# STAFF RECOMMENDATION

NCPC File No. 6423/6636

**SMITHSONIAN INSTITUTION**  
PERIMETER SECURITY AT THE NATIONAL MUSEUM OF AMERICAN HISTORY  
The National Mall, Constitution Avenue between 12<sup>th</sup> and 14<sup>th</sup> Streets, NW  
Washington, D.C.

February 22, 2007

**SITE PLAN DETAIL: MALL ENTRANCE PLAZA ON MADISON DRIVE**

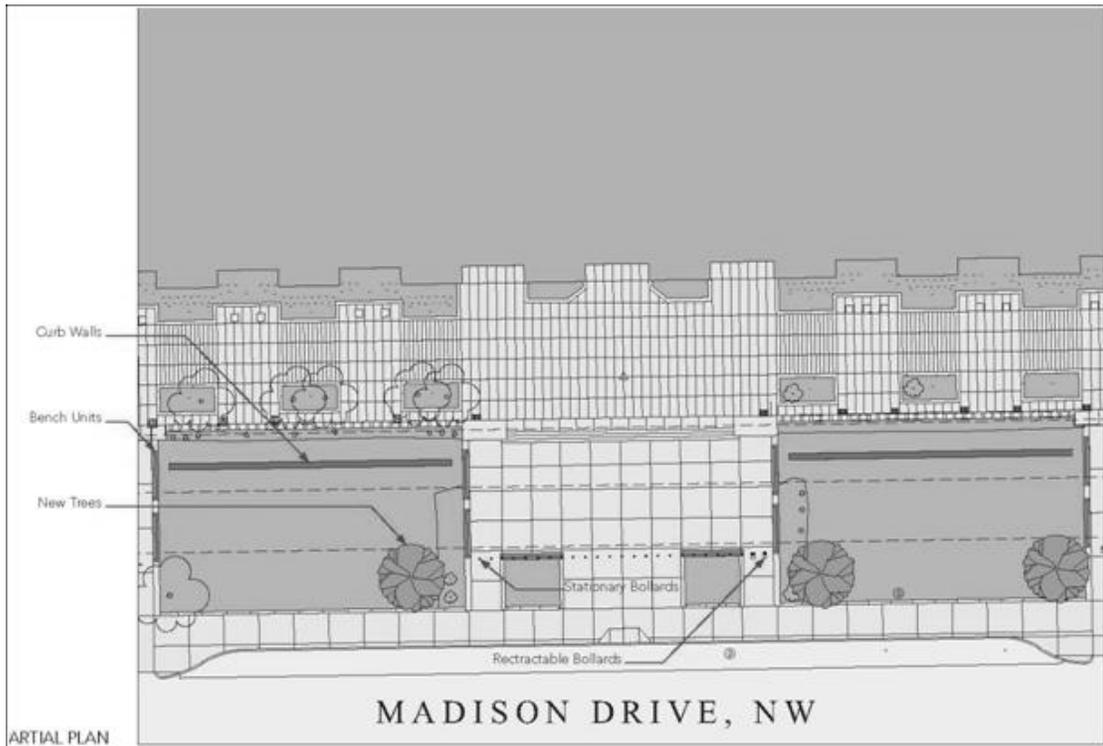
terrace entrances and entrance plaza, appear to be floating within the lawn area. **Staff recommends that SI consider incorporating foundation plantings in this area to help integrate the walls into the landscape design.**

**Recommends** that the applicant consider incorporating foundation plantings in the area between the south terrace balustrade and the proposed 24-inch high, freestanding site walls located within the Madison Drive building yard.
